AXOD/AXODE (AX4S) UPDATE HANDBOOK

*Updated
October, 2002*

Since the introduction of the Ford AXOD transaxle in model year 1986, there have been many major engineering design changes that have affected many of the parts used in the AXOD transaxle. This version of the AXOD "Update Handbook" begins with the 1986 model year and will explain each change, the parts affected by the change, and any parts interchange problems created by the change. This booklet is an updated version of the original.

Figure 18

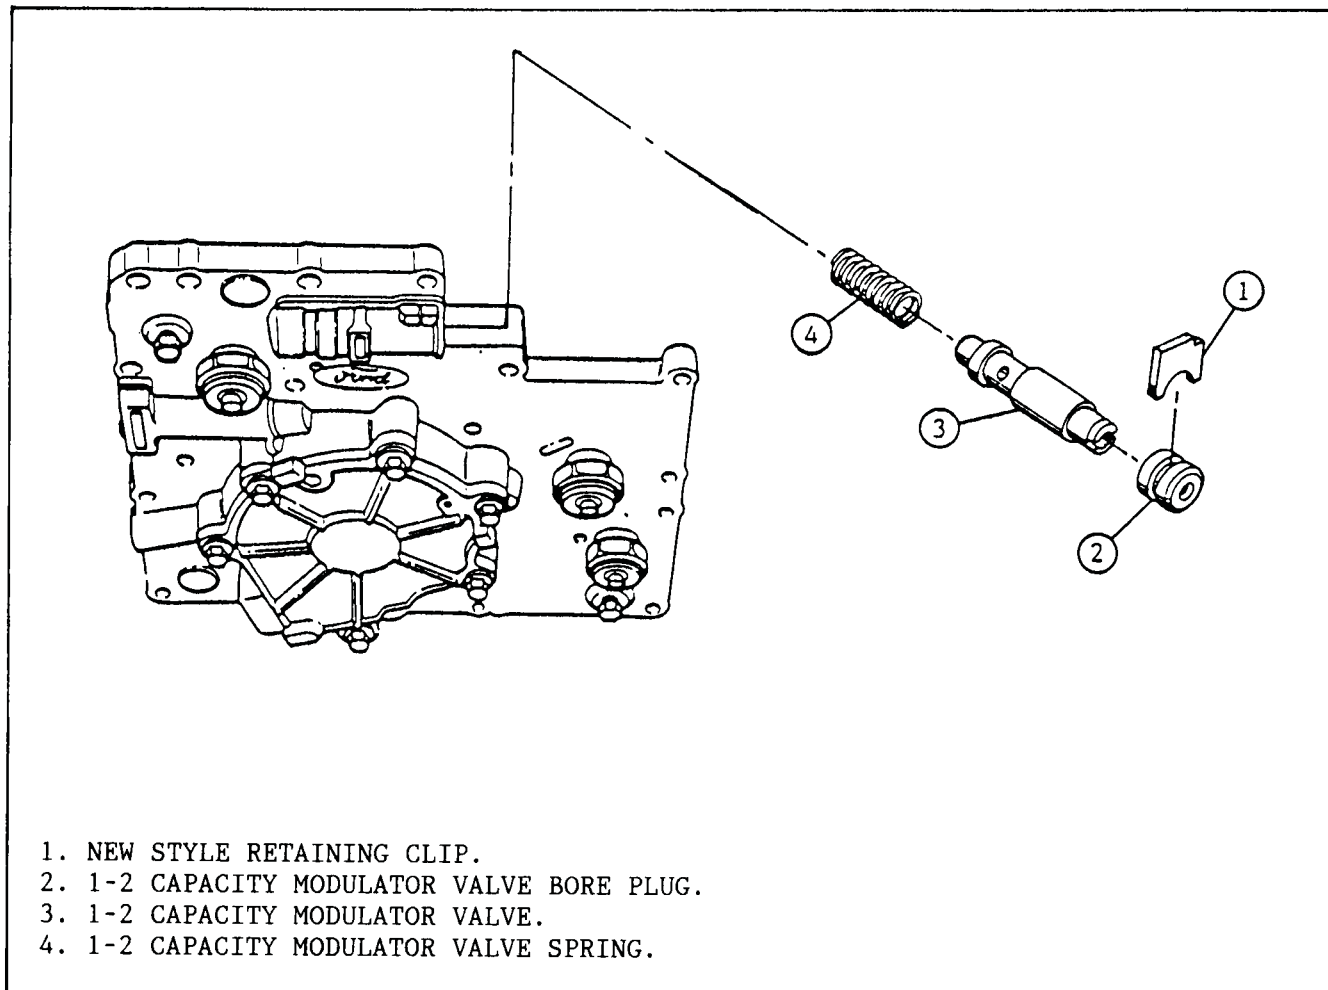
CORRECTION: FOR SOFT 1-2 SHIFT:
Replace the 1-2 capacity modulator valve spring with the Red spring manufactured by Shift Technology Products (Part #K006). The kit also comes with a new style bore plug retaining clip. Assemble into the oil pump as shown in Figure 18. This modification should be made on all AXOD'S during rebuild.

NOTE: Do not install the valve backwards, as the result will be a one-neutral shift.

Figure 19

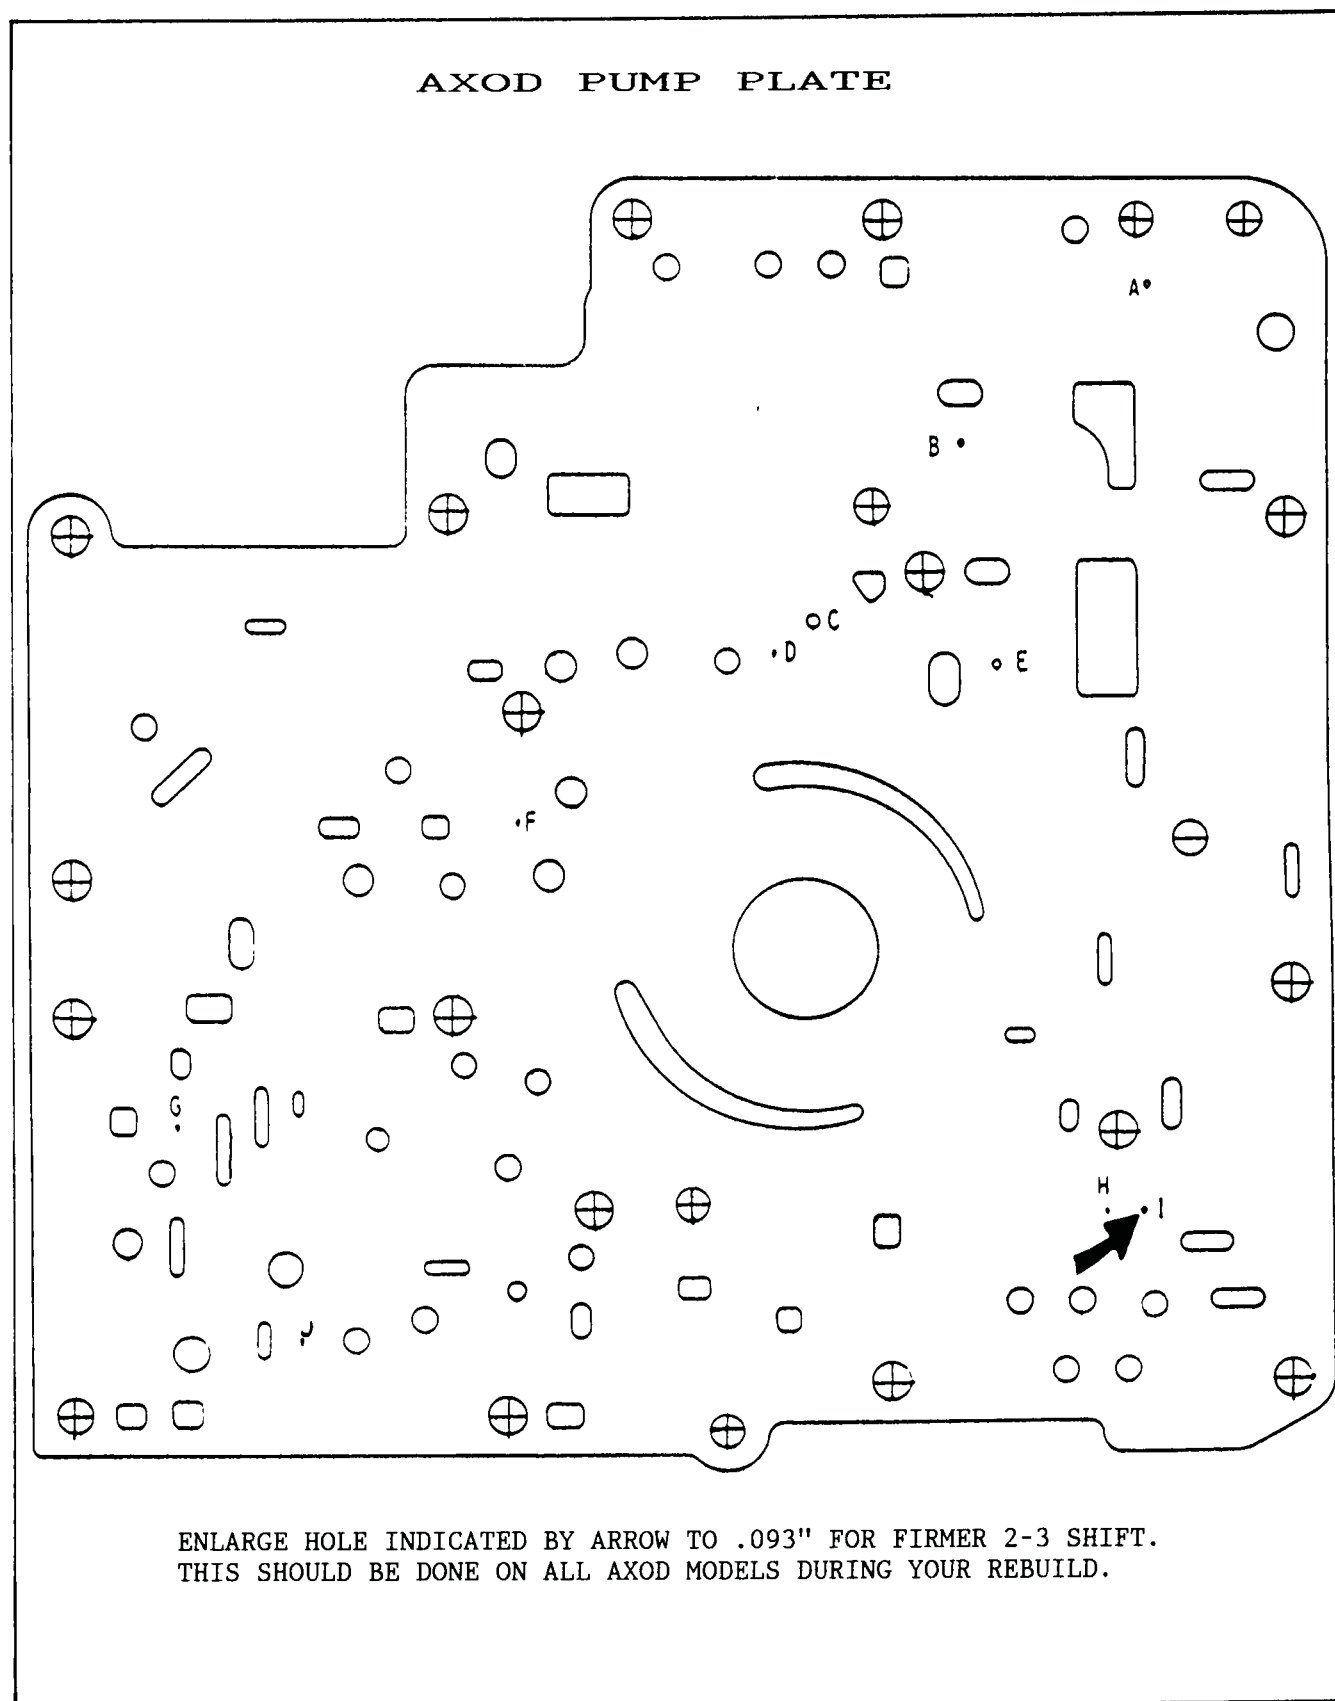
FOR SOFT 2-3 SHIFT:
Drill the direct clutch feed passage in the oil pump spacer plate, hole marked "I", out to .093" as shown in Figure 19.

Figure 29

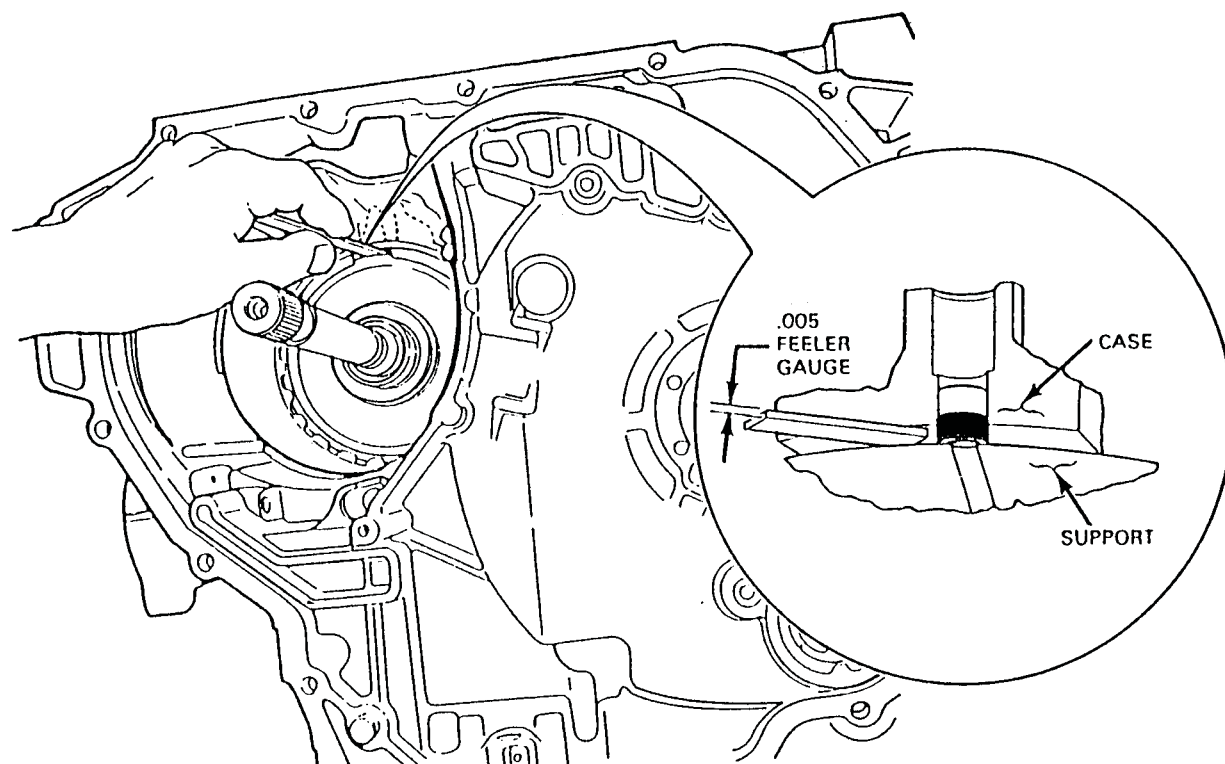
3. Inspect the bushings in the rear planetary support, as these bushings can move out of position and block the lube oil hole located in the support between them. The 1988 and later rear planetary support has a new design, wider, one piece bushing with a groove and lube hole in the center. This will provide more surface area to prevent the bushing from moving. Refer to Figure 29.
The later rear planetary support, with the 2nd design bushing, will retro fit back to ALL previous models and is highly recommended. The new design rear planetary support is available under OEM part number E6DZ-7A130-A.

THE LATER REAR PLANETARY SUPPORT, WITH THE 2ND DESIGN BUSHING, WILL RETRO FIT BACK TO ALL MODELS AND IS HIGHLY RECOMMENDED.

Figure 31

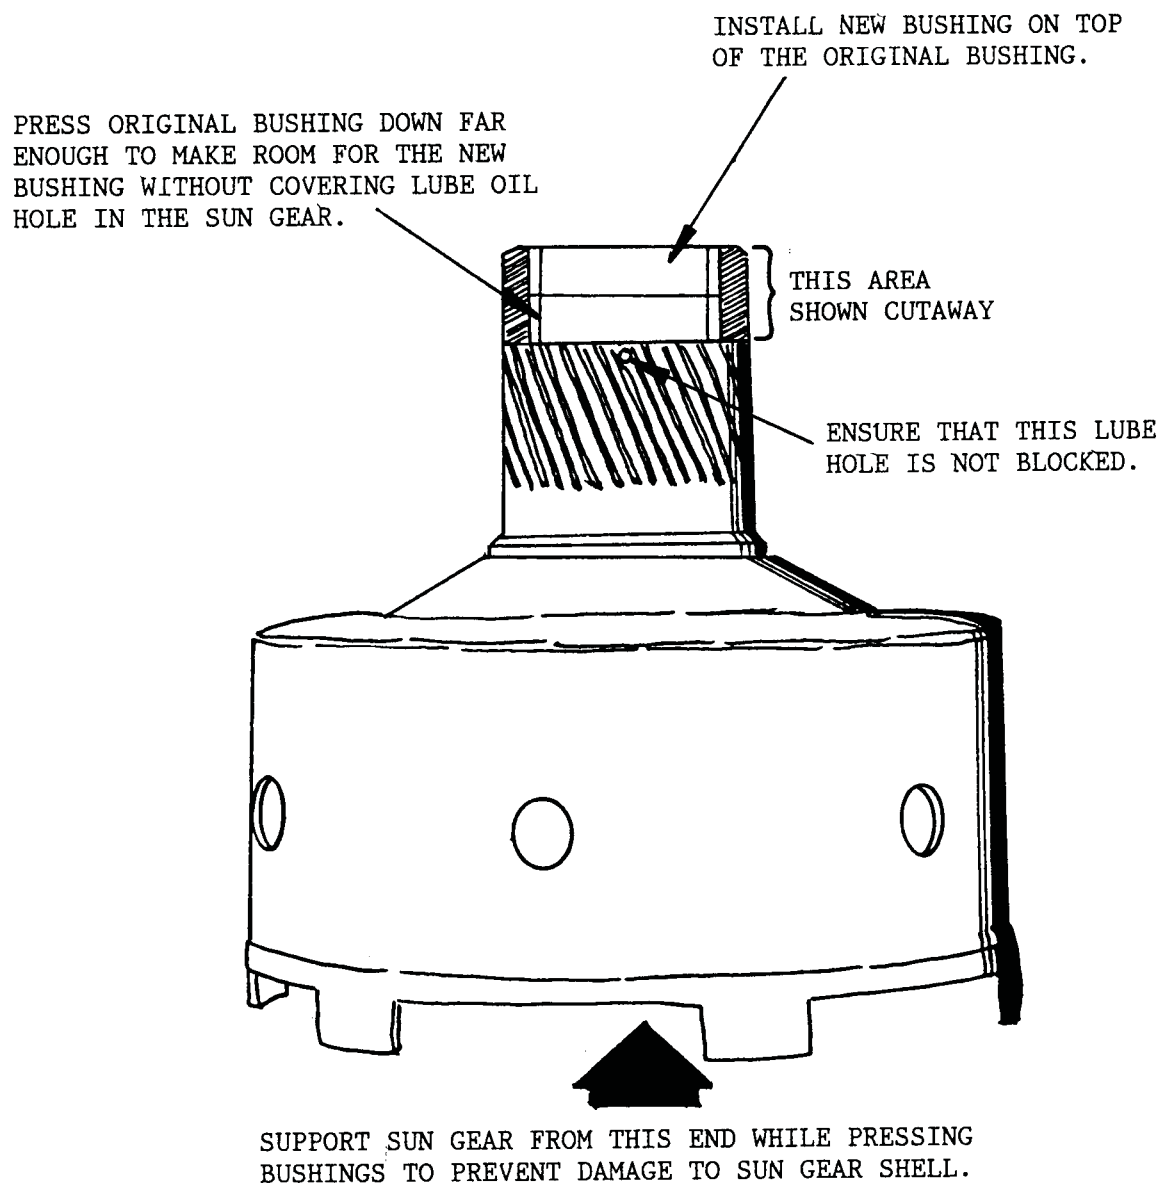
5. Install "Double Bushings" at the rear of sun gear as shown in Figure 31. After both bushings are in place, ensure that lube oil hole in the sun gear is not blocked.

Figure 32

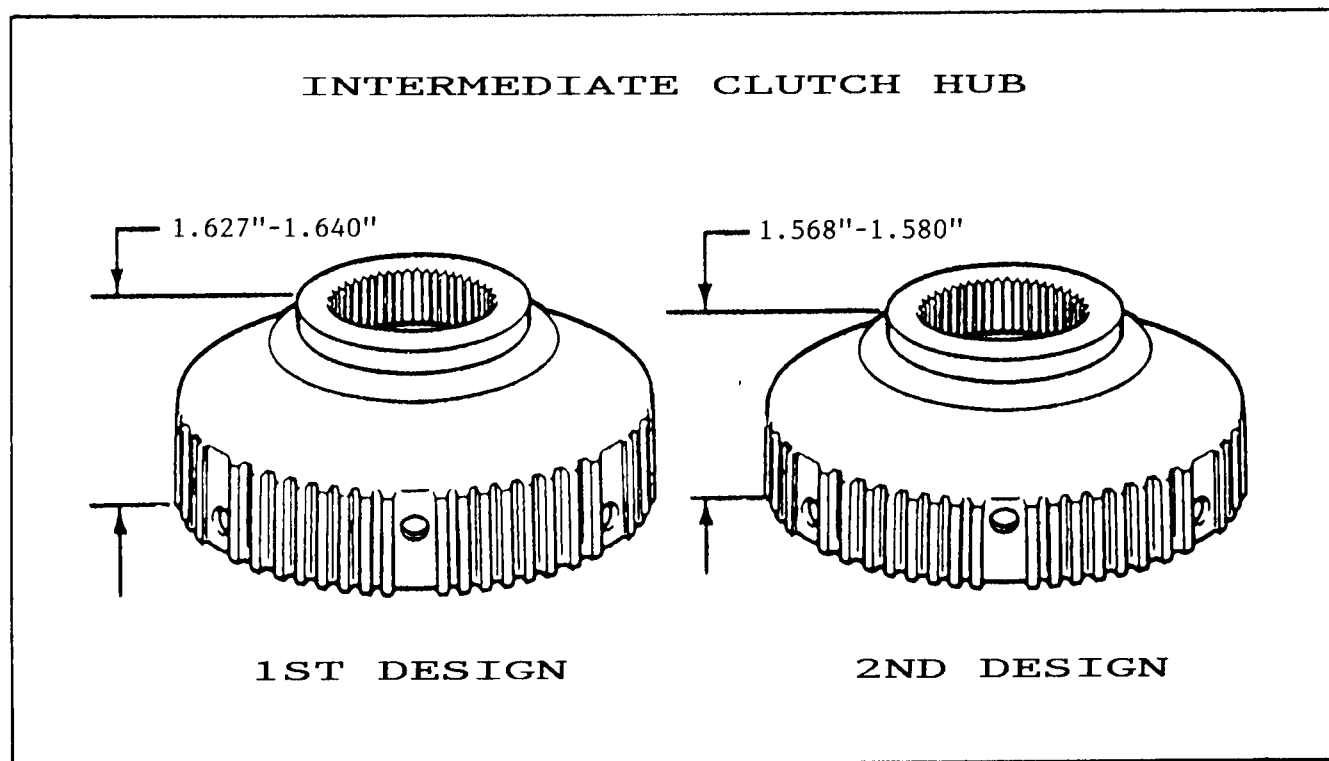
- (2) **INTERMEDIATE CLUTCH HUB** - Overall height was made shorter by approximately .060" with no identifying marks. The hub **MUST** be measured with a dial caliper or depth gage.
The 1st design hub will measure 1.627"-1.640", and the 2nd design hub will measure 1.568"-1.580" as shown in Figure 32.

Figure 35

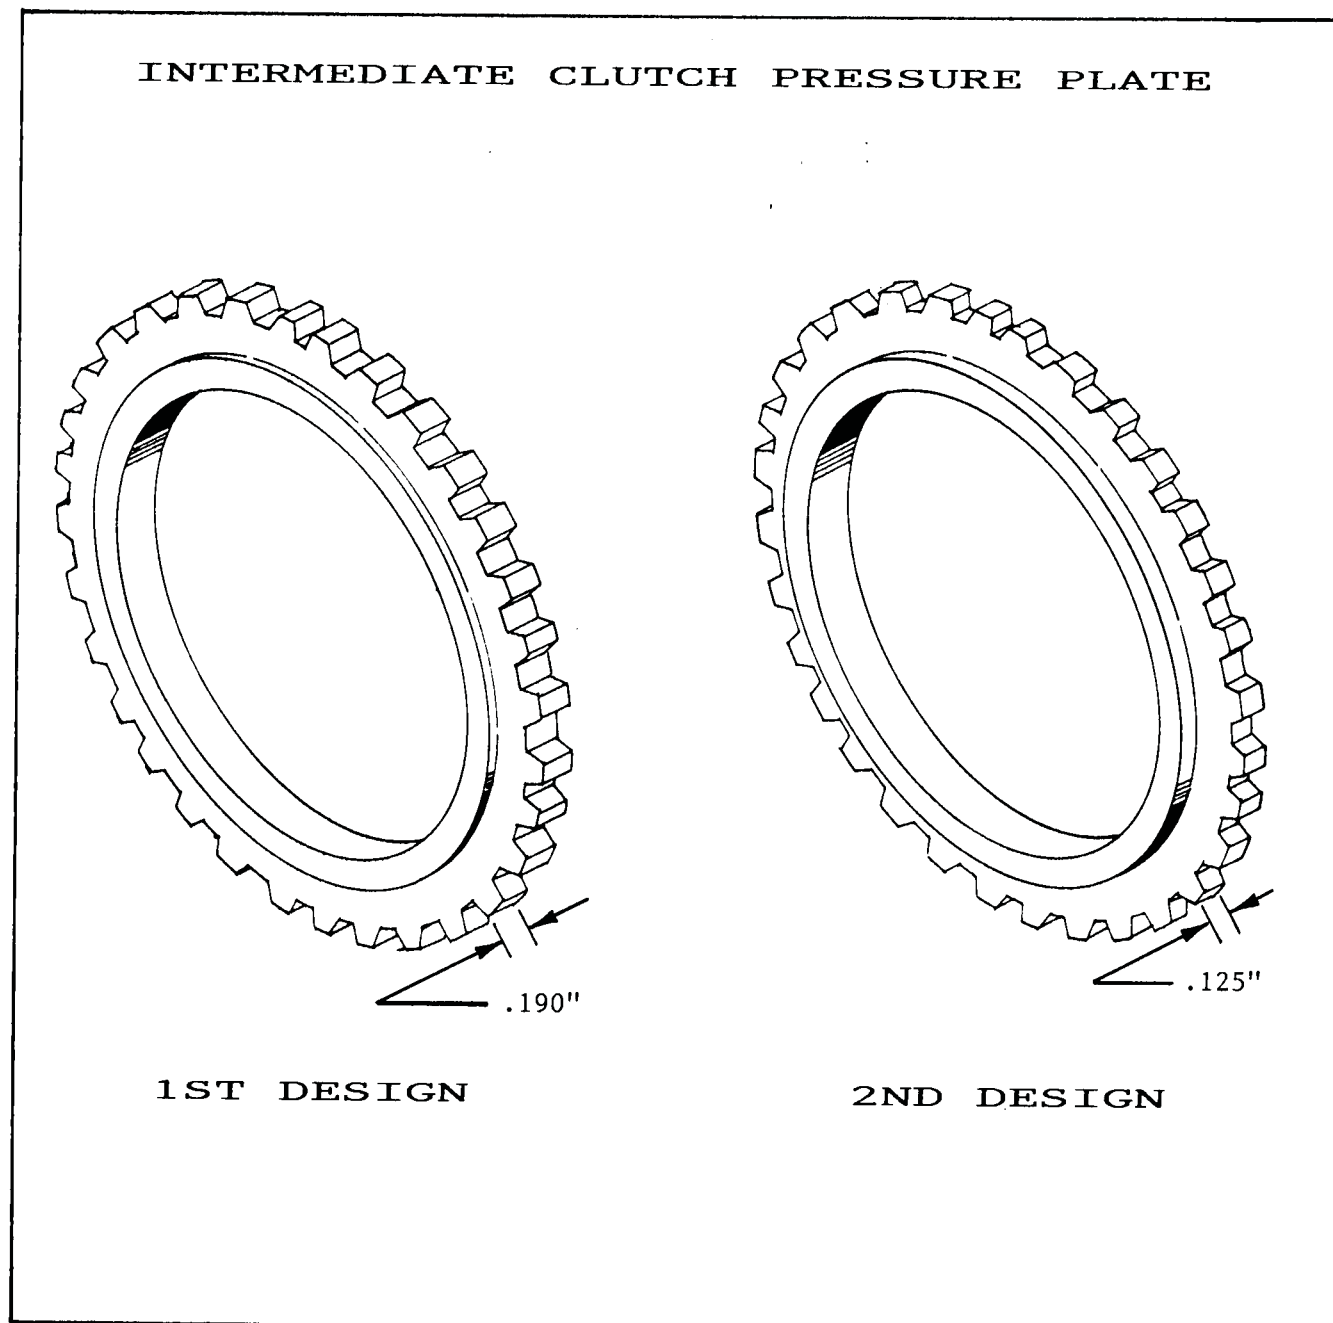
- (4) **INTERMEDIATE CLUTCH PRESSURE PLATE** - Thickness was reduced by .065" to help accomodate the added wave plate on 3.8L models, or the added spacer plate on 3.0L models.
The 1st design pressure plate is .190" thick, and the 2nd design pressure plate is .125" thick as shown in Figure 35.

Figure 37

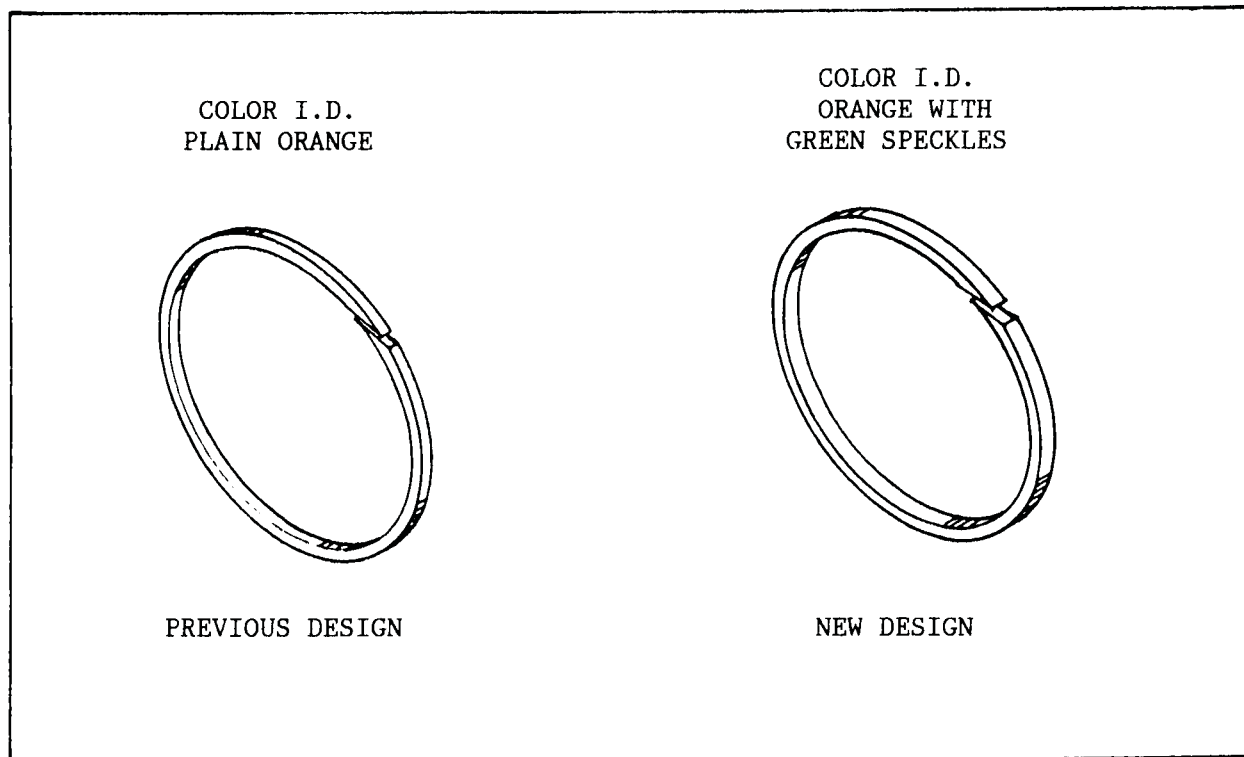
The five sealing rings on the driven sprocket support have been re-designed to help eliminate leakage in this area. The width of the sealing rings has been increased by approximately .015", and the new color identification is orange with green speckles (See Figure 37). The previous design sealing rings were plain orange in color.

The new design sealing rings are available under OEM number E6DZ-7D019-A, and should be used on ALL previous model AXOD transaxles.

DO NOT USE PREVIOUS DESIGN SEALING RINGS.

Figure 38

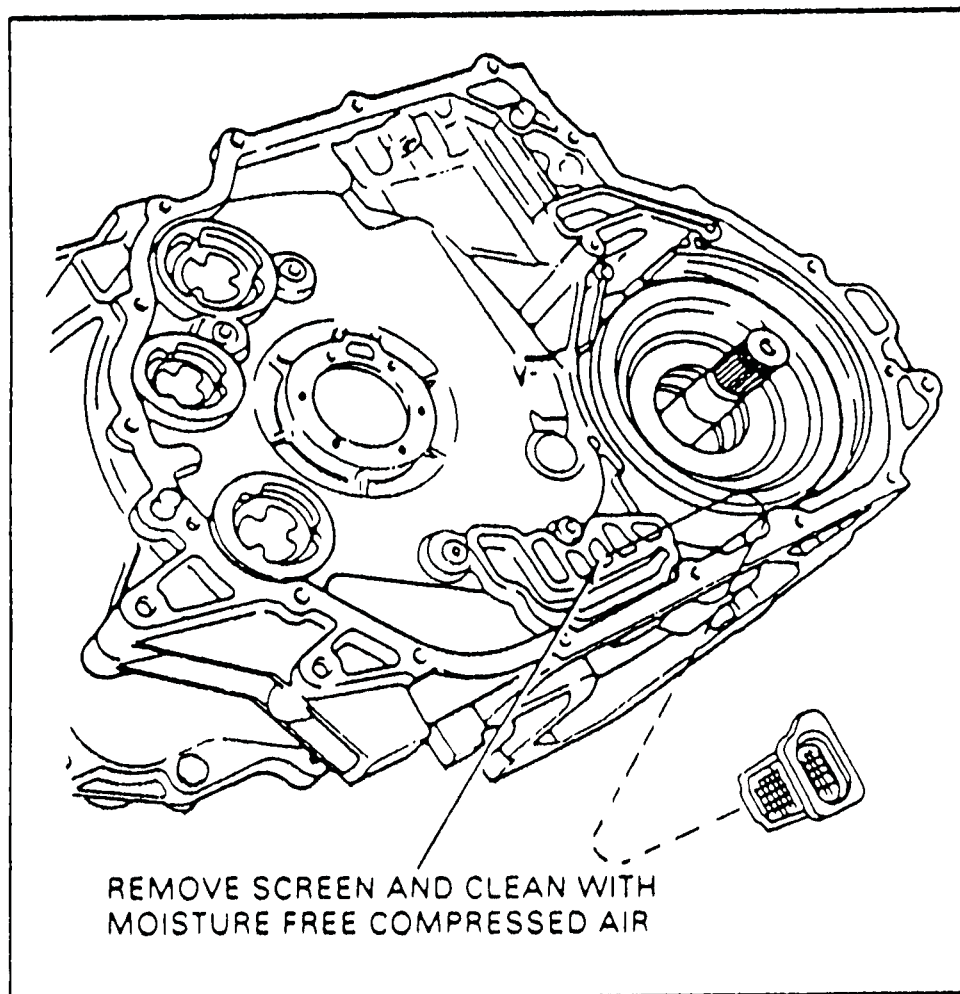
CHANGE: A new filter has been added to the 1989 AXOD 1-2 servo apply circuit as shown in Figure 38.
